ADDENDUM NO. 3

TO: PLANS AND SPECIFICATIONS FOR STATE OF MISSOURI

**USB Roof Replacement & Latrine Renovation
Chillicothe Readiness Center
1500 Washington St.
Chillicothe, Missouri 64601
PROJECT NO.: T2519-01**

September 2, 2026

SHEET TITLE:
SITE LAYOUT PLANS

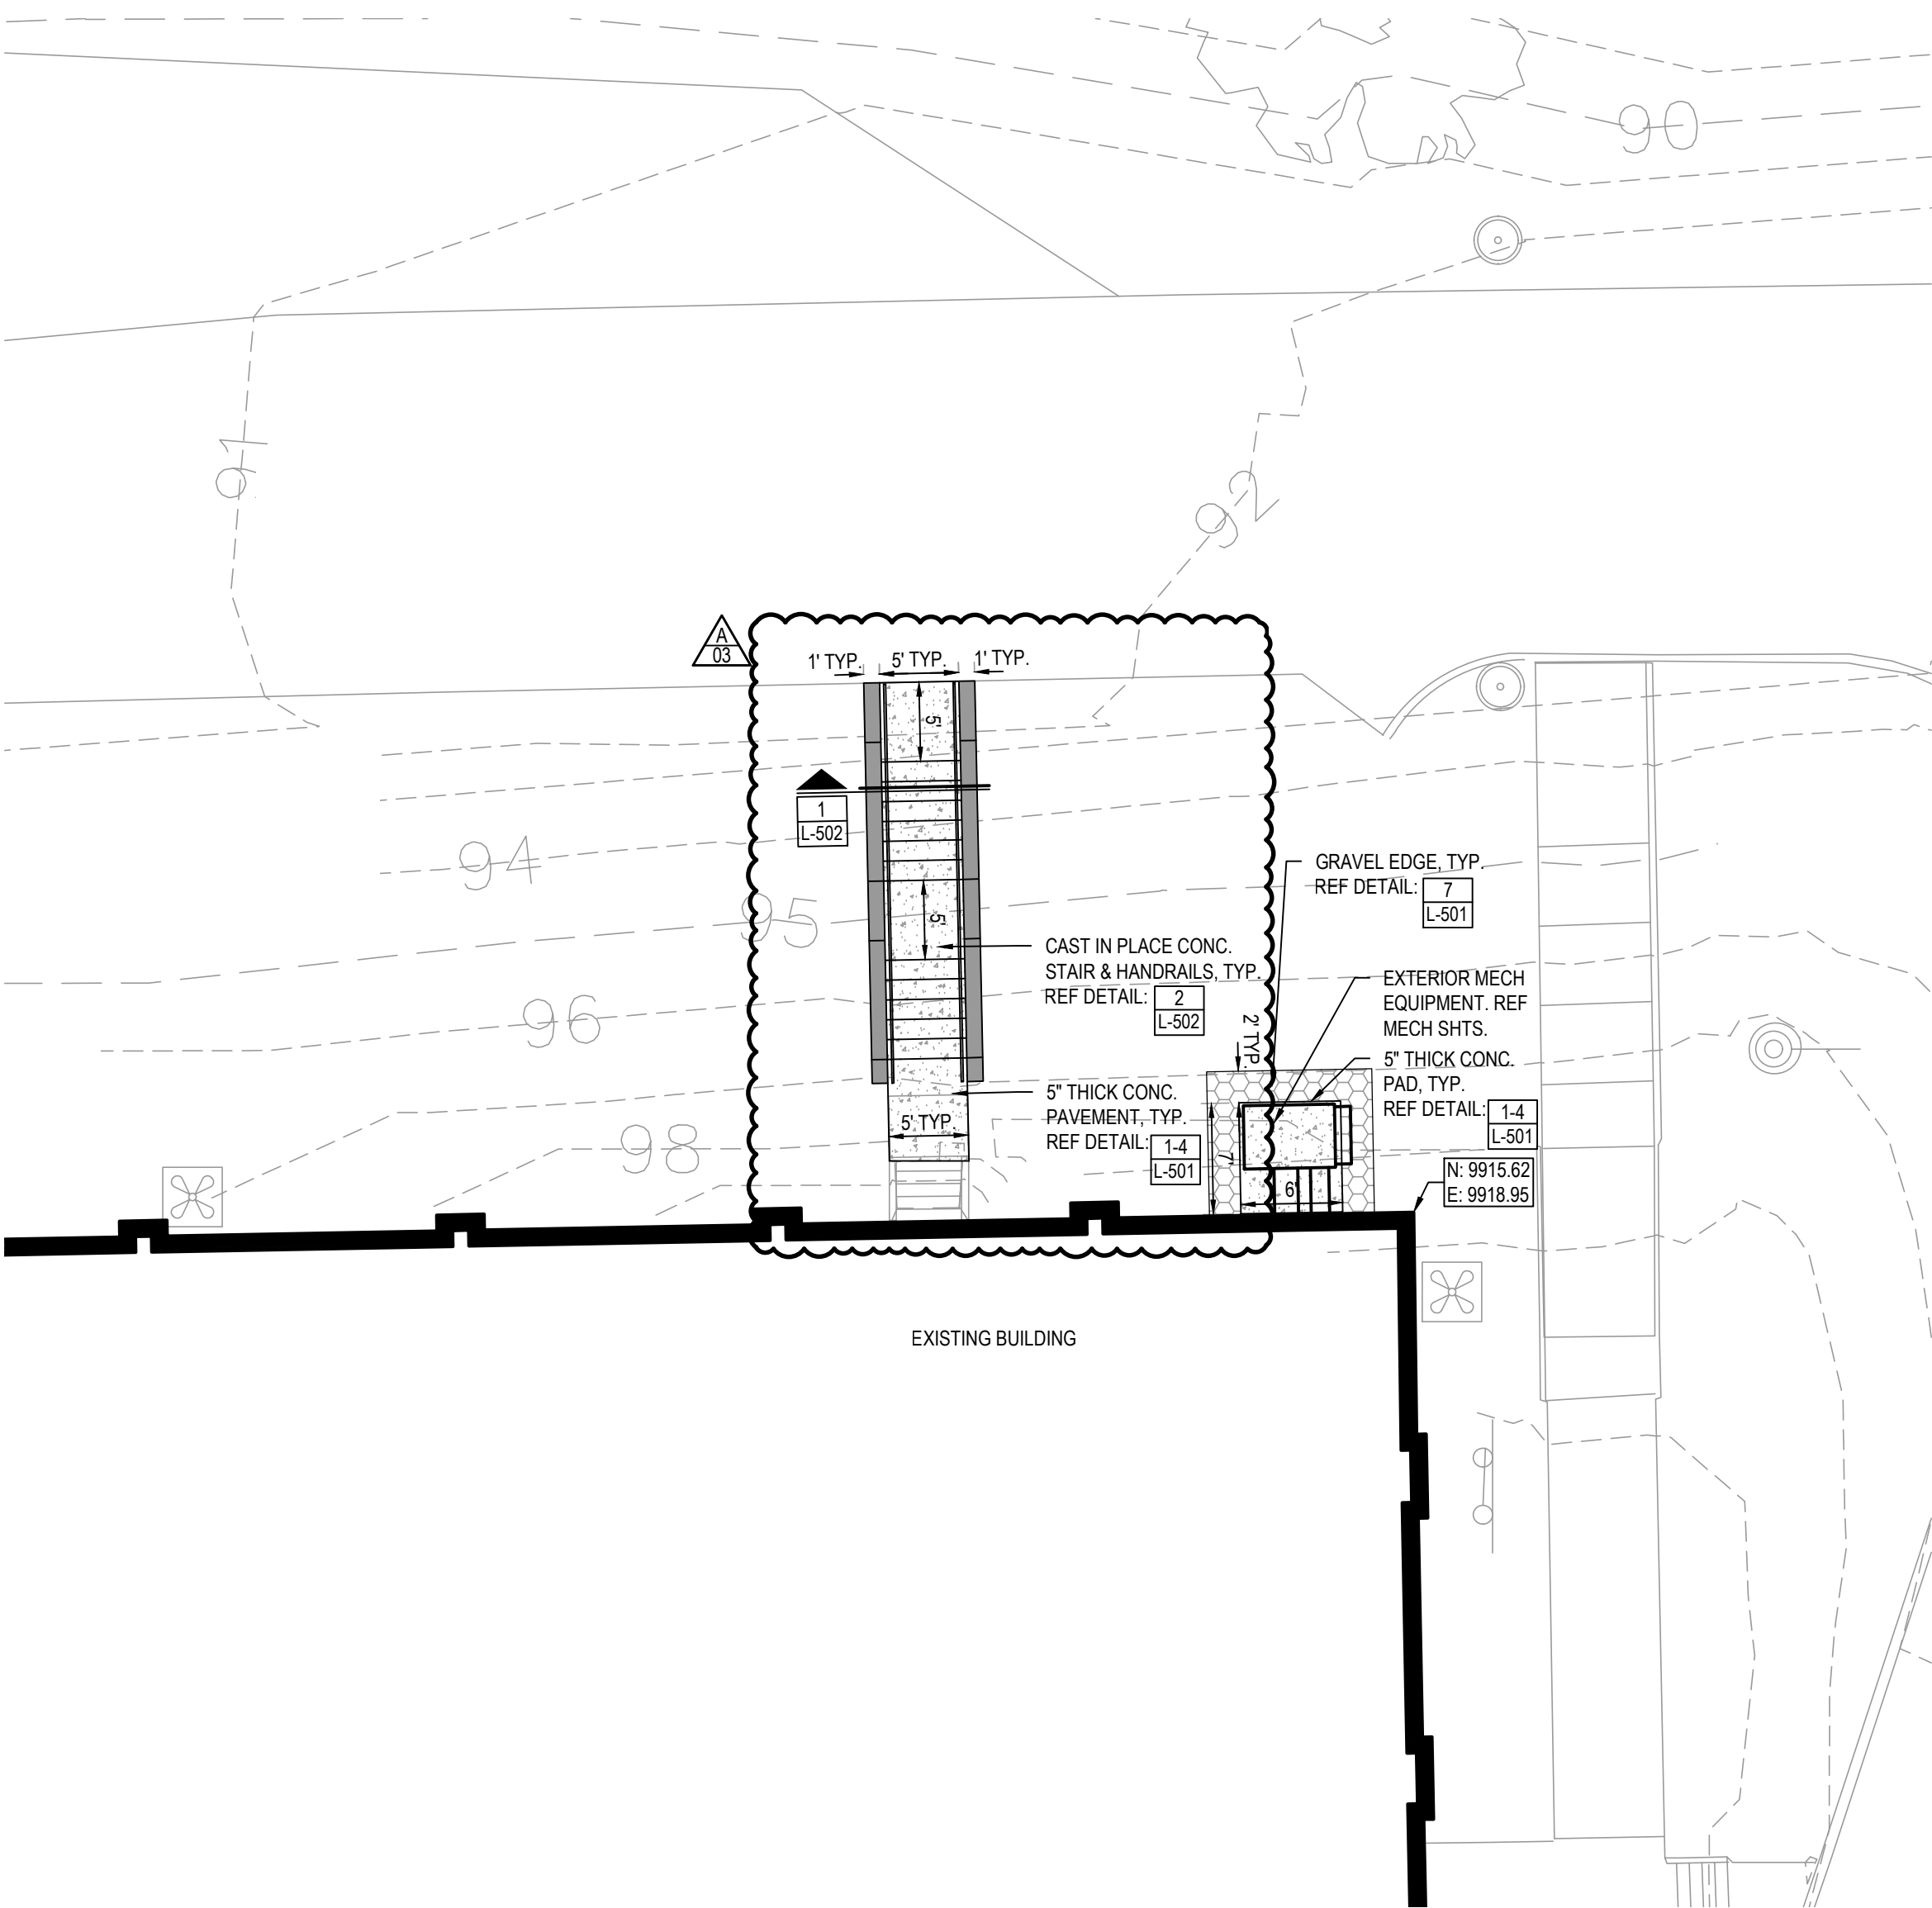
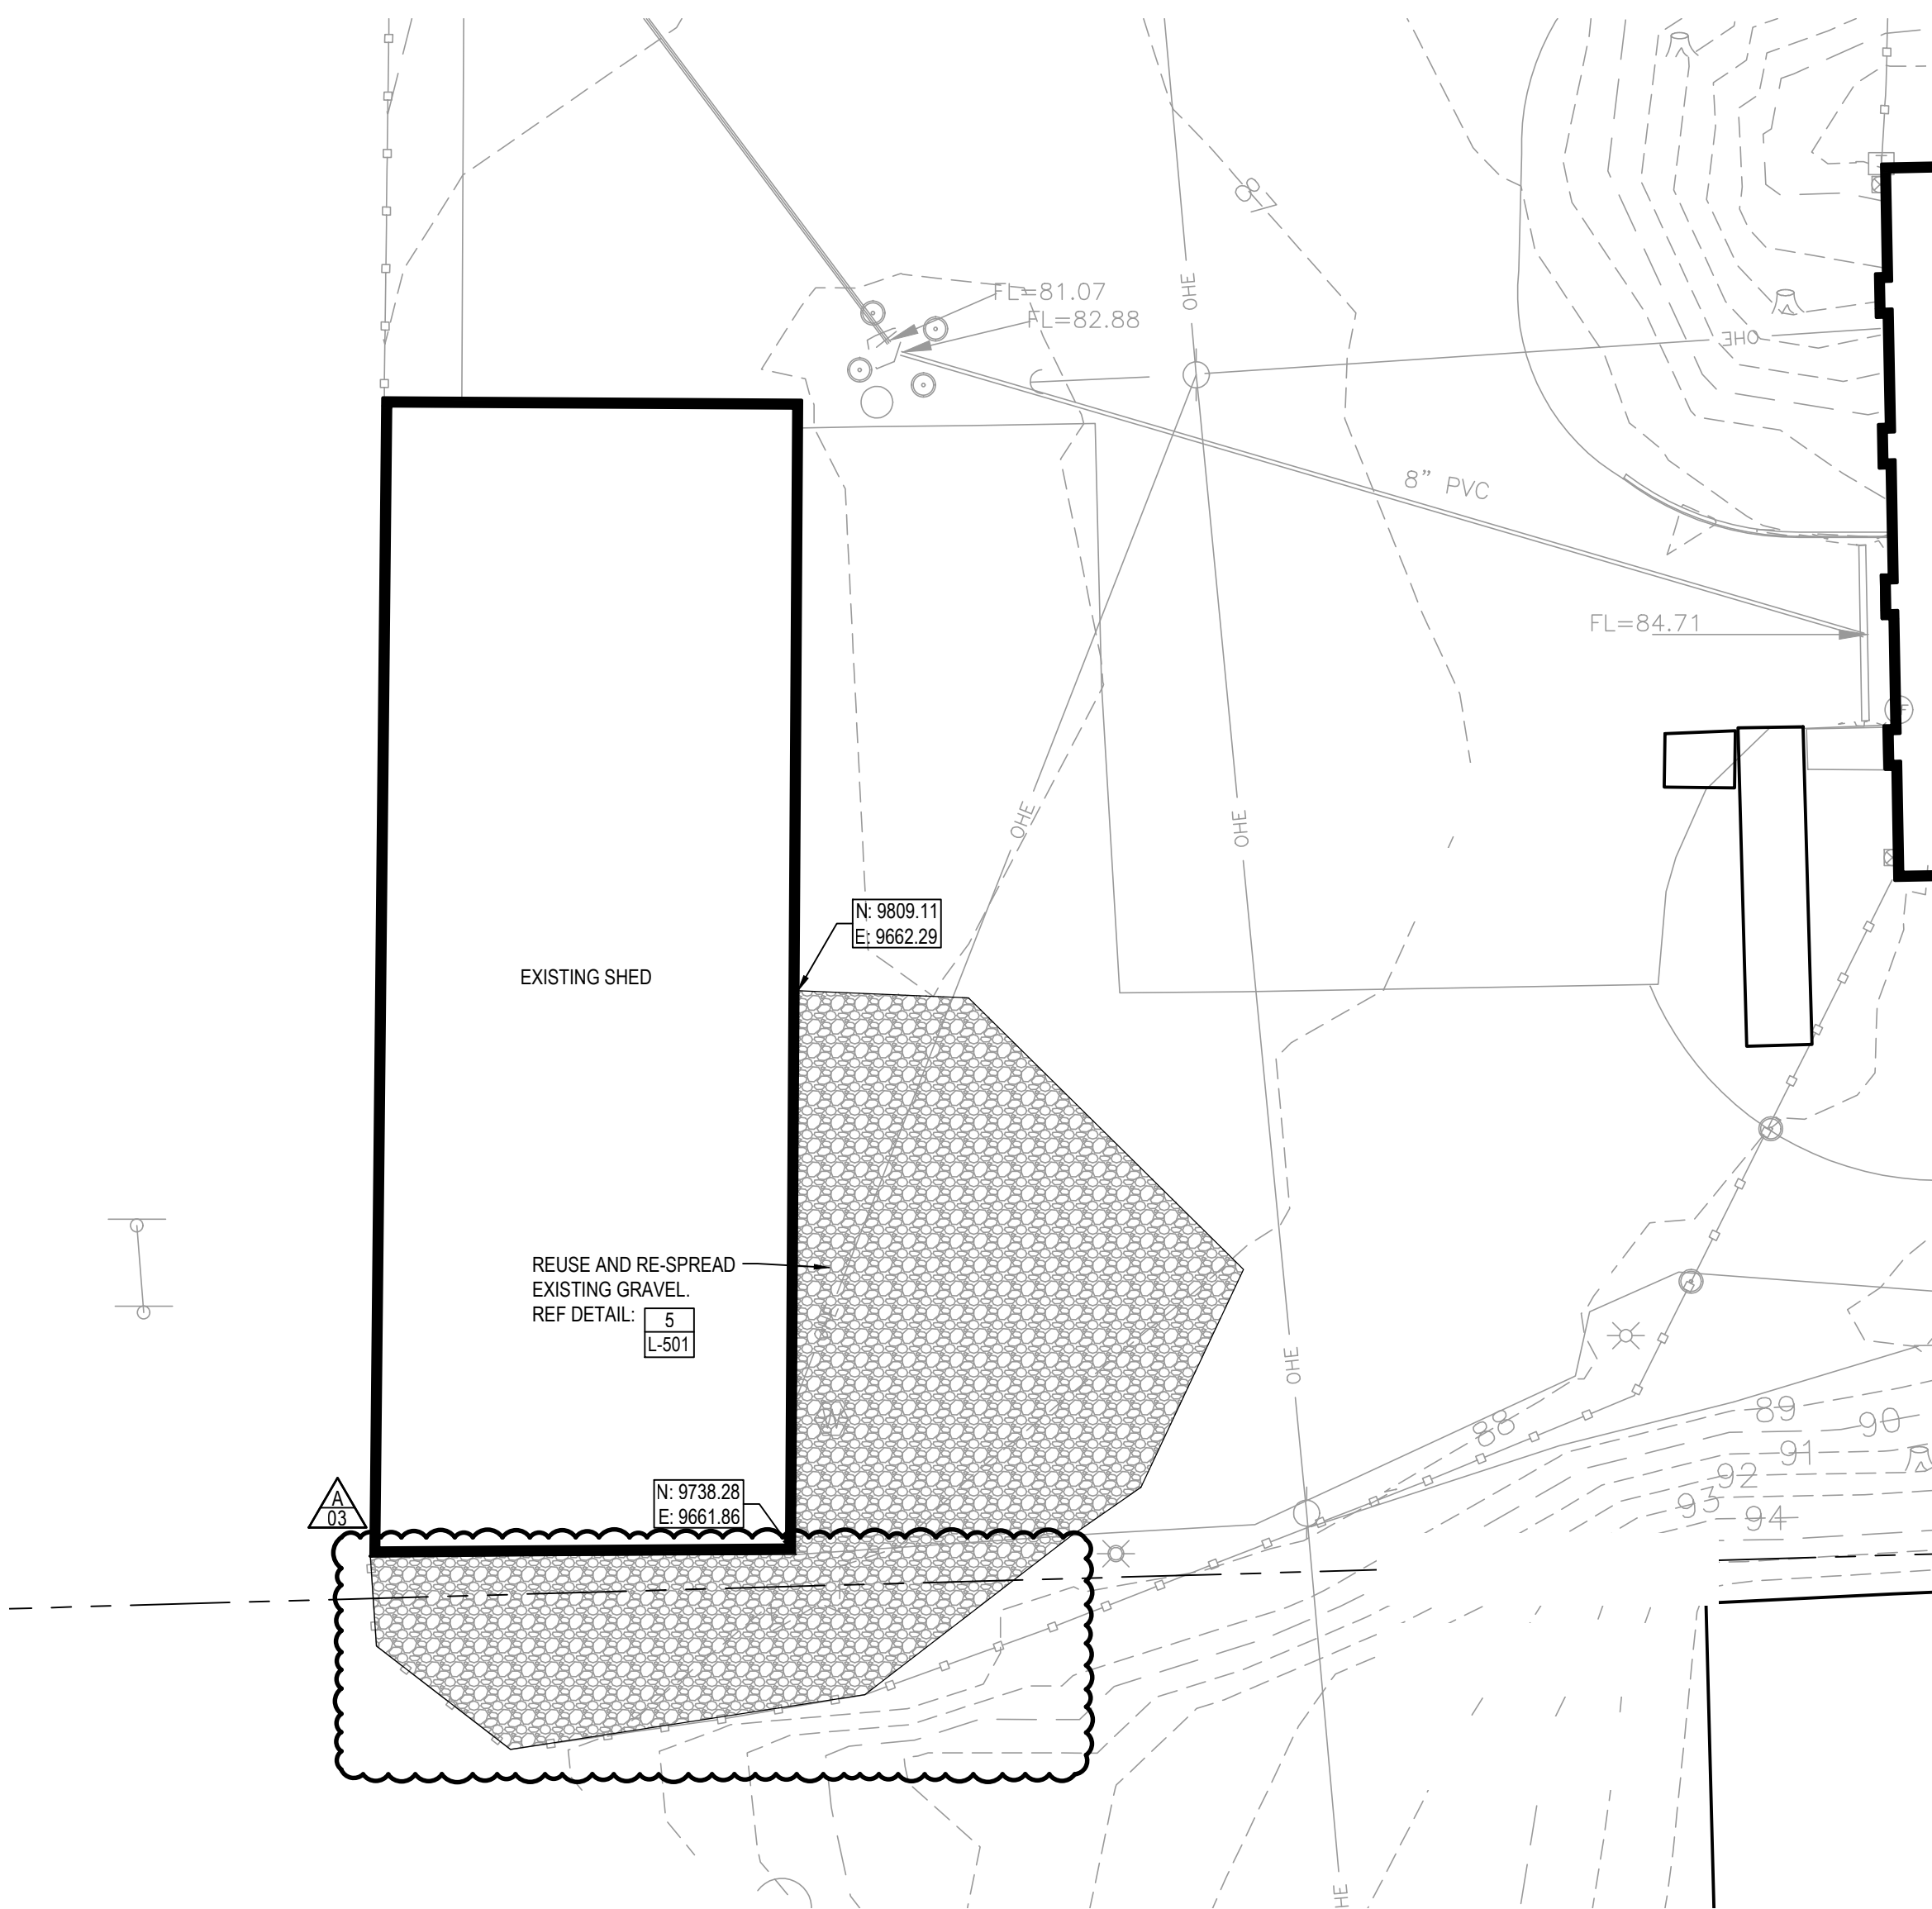
1. Sheet L-101 – Existing Conditions and Demolition Plan
 - a. ADDED demolition of existing north stair landing.
2. Sheet L-201 – Site Layout Plans
 - a. REVISED site conditions.
3. Sheet L-301 – Site Grading Plans
 - a. REVISED site conditions.
